Docket Item #12
BAR CASE # 2007-0002

BAR Meeting
March 21, 2007

ISSUE: Addition and alterations
APPLICANT: Amy & Brien Biondi
LOCATION: 833 South Lee Street
ZONE: RM/Residential

The applicant is requesting approval of a Certificate of Appropriateness for a new third story and a new side addition for the end unit residential rowhouse at 833 South Lee Street.

Figure 1 - Proposed east elevation

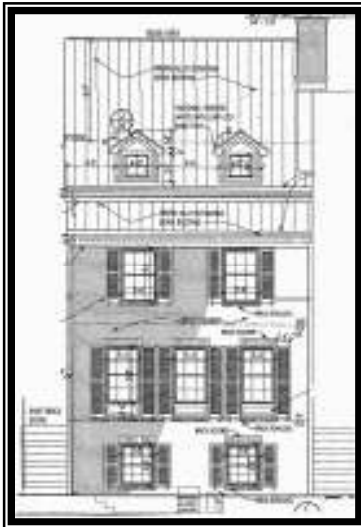
An addition is proposed to be constructed onto the east elevation of the house, facing South Lee Street. The addition is proposed to be constructed of brick to match the existing house. As proposed, new addition will extend 6' from the face of the existing rowhouse and will project approximately 2' from the front façade of the townhouse immediately to the north. The front addition will extend across the full width of the house, approximately 22'4", with a slight indentation of 4" from the Green Street elevation of the house.

While shown on the submitted plat and elevations, a small recessed areaway with a brick surround at the ground level to house a new exterior a/c unit will not be constructed, in order to meet open space requirement. The detailing on the east elevation of the addition has been revised substantially since the prior submittal to be more simplistic and in keeping with the detailing of Yates Garden. On the ground/first level there will be two six-over-six windows; on the second level three ganged double-hung six-over-six windows. Brick soldier courses and brick rowlock will be located above and below the windows on these levels. On the third level there will be two, six-over-six, double-hung windows. All the windows will have wood, operable shutters, sized to fit the openings.

A pair of gabled dormers with four-over-four windows are proposed for the upper slope of the roof of the new east elevation. The roof line will be interrupted by a dentil moulding and cornice, to break up the massing of the additions.

Another challenge with this particular end unit rowhouse is the unusual combination of a flat roof and a gabled roof, intersecting on what functions as the main façade. The proposed scheme of adding a third floor under a front facing gable roof may be viewed as imposing a cleaner and finished design to this elevation and producing a true front façade. By staggering the roof line on the east elevation, the projecting 6' addition clearly reads a new addition. However, staff would prefer that a deeper recess or indentation at the addition, to provide an even more visible break between the main house and the new east addition.

Figure 2 - Proposed south elevation

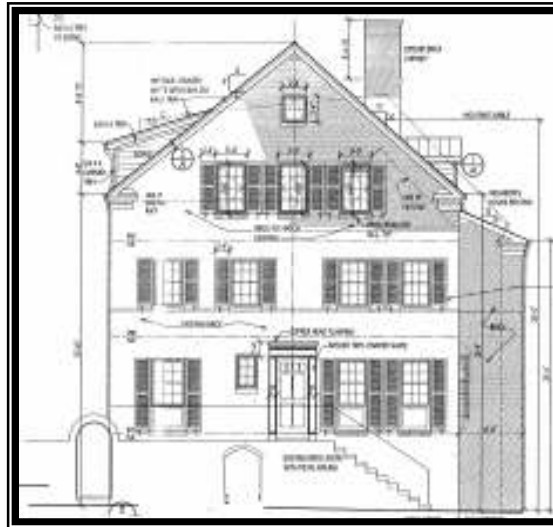
The roof peak will be raised approximately 14' on the west side with a new front roof pitch of 9/12 on the Green Street elevation. The new raised gable roof will have a ridgeline, approximately centered on the front door. On the west slope of the new roof, a shed roof dormer with a pitch slope of 3.5/12 will be installed. The west elevation will have minimal fenestration with two awnings style windows. This new section of the addition will be sheathed in HardiPlank. The gable end (south face/Green Street) of the new third story will be sheathed in brick to match the existing. Three ganged windows will be installed on the new third floor, with a single awning window in the gable. It is unclear if the new windows are casement type windows (applicant should clarify this at the meeting). The roof of the gable slope will be a prefinished standing seam aluminum roof with wood rake boards. The roof on the rear slope of the addition will match. The existing chimney will be extended 5'2/12".

While staff still maintains some reservations about this proposal, staff believes the applicant has made considerable changes and revisions to the scheme that merit support. Therefore, staff recommends approval, with clarification of the proposed windows on the third floor facing Green Street.
